# D/DRC Case

2619 Lee Street

**DESIGN/DEVELOPMENT REVIEW COMMISSION**  
**DESIGN REVIEW DISTRICT**  
**HISTORIC AGENDA**  
**EVALUATION SHEET**  
**Case #11**

**NATURE OF REQUEST:** Request Certificate of Design Approval for new construction

**LEFT SIDE ELEVATION**

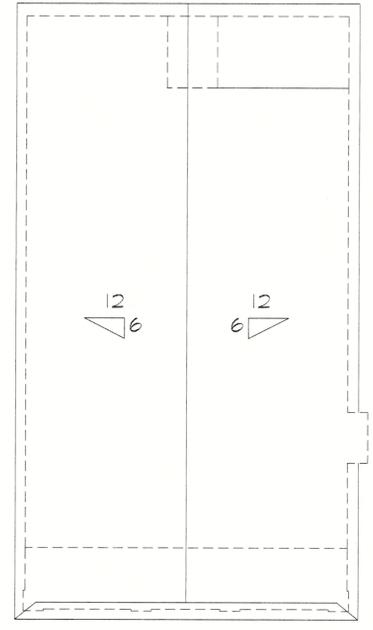
Staff recommends revising the fenestration on the left side elevation to include one additional full-size window near the front and changing the fixed window to a smaller double hung unit. Staff also recommends changing the chimney material from siding to brick, and simplifying the window/door crowns to typical Craftsman headers.

7. *Rhythm of Openings: Construct new buildings so that the relationship of width to height of windows and doors, and the rhythm of solids (walls) to voids (door & window openings) is visually compatible with historic buildings on the block or street. Maintain a similar ratio of height to width in the bays of the façade.*  
The windows and doors create an acceptable rhythm of openings that is visually compatible with historic buildings nearby. As stated above in #3, staff recommends adding one window on the left side elevation and changing the fixed window to a smaller double hung unit.

- Setback of the house shall be in line with existing adjacent houses
- The fenestration on the left side elevation shall be revised to include one additional full-size window near the front and changing the fixed window to a smaller double hung unit
- The chimney material shall be changed from siding to brick
- All elevations shall feature simplified Craftsman window headers and trim
- The front steps shall be constructed of brick and/or concrete
- All details deferred to staff.
